Editor

Dear Rodrigo Aguayo, and co-authors,

Anonymous Referee #1

In the manuscript “Assessing the glacier projection uncertainties in the Patagonian Andes (4-56 S) from a catchment perspective”, a large set of glacier model simulations obtained with the OGGM model is used to assess the uncertainty in glacier runoff and glacier melt projections. The study looks at the effect of different glacier outlines, different glacier volume estimates, various historical climate datasets, different GCM, different emission scenarios and different bias correction methods. Each of these different datasets are discussed and it is shown how they vary, mainly focusing on their spatial patterns. Using a random forest regression method, the relative importance of each of these “model choice” uncertainties is examined. The study concludes that the reference climate is the most important source of uncertainty for a range of glacio-hydrological signatures, even for signatures that represent a signal beyond the reference period.

Figure R1. Volume loss (in percentage) vs. Latitude. The size of the circles is proportional to the glacier volume.

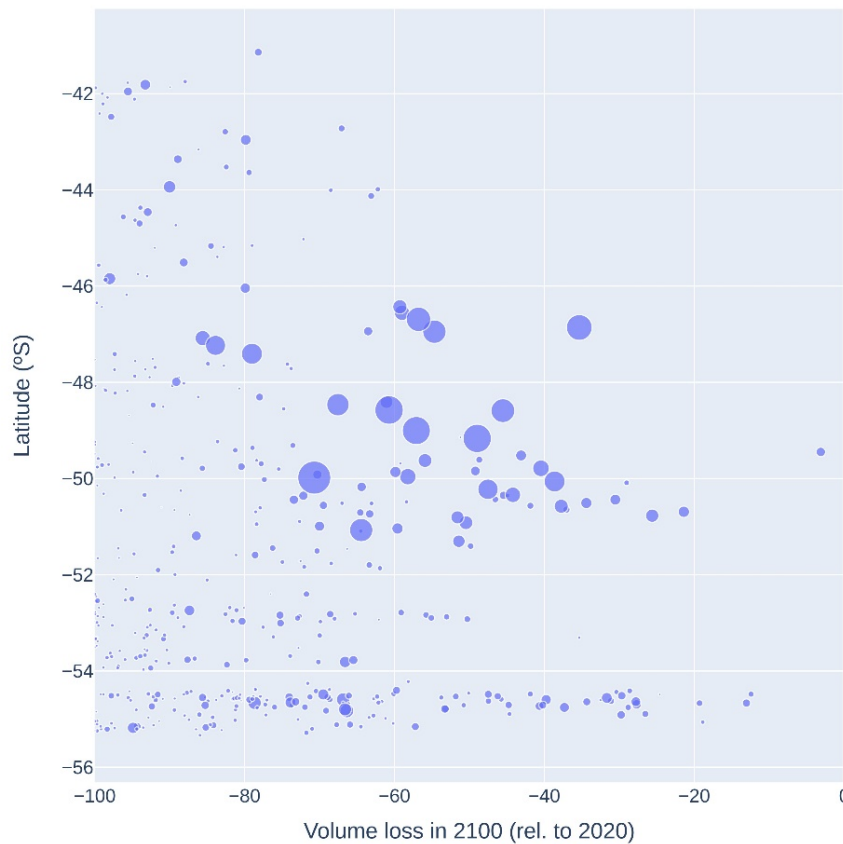
Ln 539: Just to clarify, 43% of the catchment will lose 80% of their glacial volume? Also, there is latitudinal dependence (North-South divide). Can you talk more about that?

R: Yes, considering the mean derived from the full set of SSP scenarios (n = 1920), 18% of the total glacier area will lose more than 80% of its current volume this century (the use of % of catchment area has been removed from the manuscript to avoid adding unnecessary complexity to the study).

Regarding the latitudinal dependence, it's interesting to note that while there are clear latitudinal patterns in precipitation projections (Fig. 6), no clear latitudinal pattern was observed in volume loss (Fig. R1). This suggests that volume loss is influenced by a variety of factors beyond just latitude-dependent variables. Initial volume, ice dynamics and climatological features all play an important role in shaping patterns of ice loss. This underscores the complexity of the processes driving changes in ice volume and highlights the need for a comprehensive understanding of the different sources of uncertainty.
